# SITE PLAN REVIEW AND APPEARANCE BOARD

## ---STAFF REPORT---

**MEETING DATE:** February 22, 2017

**AGENDA ITEM:** AutoNation Delray Beach (File #2016-268) – Class V Site Plan, Landscape Plan and Architectural Elevations associated with construction of a 105,400 square foot automobile dealership at 1311 West Linton Boulevard.

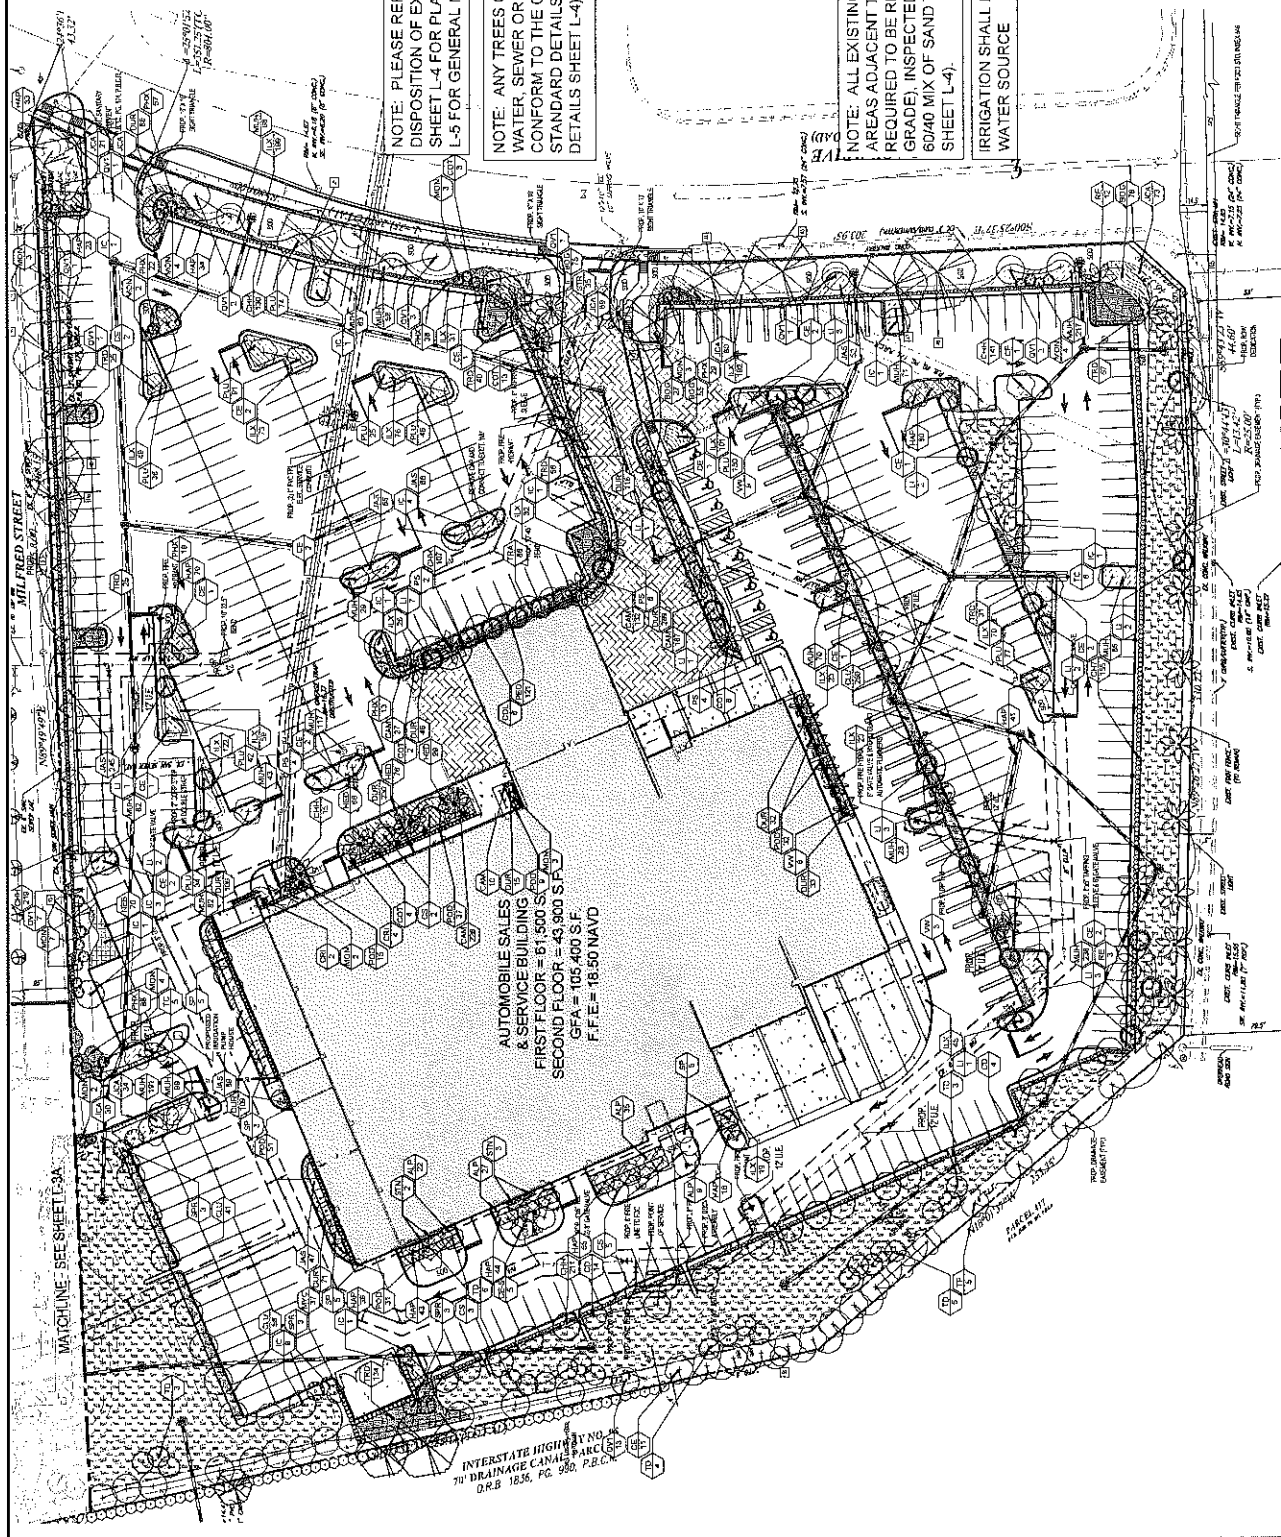
Per LDR Section 4.6.16(H)(3)(i), landscape islands which contain a minimum of 135 square feet of planting area, with a minimum dimension of 9 feet, exclusive of the required curb, shall be placed at intervals of no less than one landscaped island for every 13 standard parking spaces. One shade tree shall be planted in every island with a minimum of 75 square feet of shrubs and groundcovers. Tree specifications shall adhere to those listed in Section 4.6.16(E)(5) and 4.6.16(E)(6). Where approval for the use of compact parking has been approved, islands may be placed at intervals of no less than one 1 island for every 15 compact parking spaces. This landscape island is required for the display parking spaces along Linton Boulevard, where 27

and 14 parking spaces are provided in a row without the required landscape island. A condition of approval is attached that the plans be revised to provide the required interval of landscape islands and landscaping.

Move approval of the landscape plan for **AutoNation Delray Beach**, by adopting the findings of fact and law contained in the staff report, and finding that the request is consistent with Section 4.6.16 of the Land Development Regulations, subject to the condition that the plans be revised to provide the required interval of landscape islands and landscaping prior to certification of the site plan.
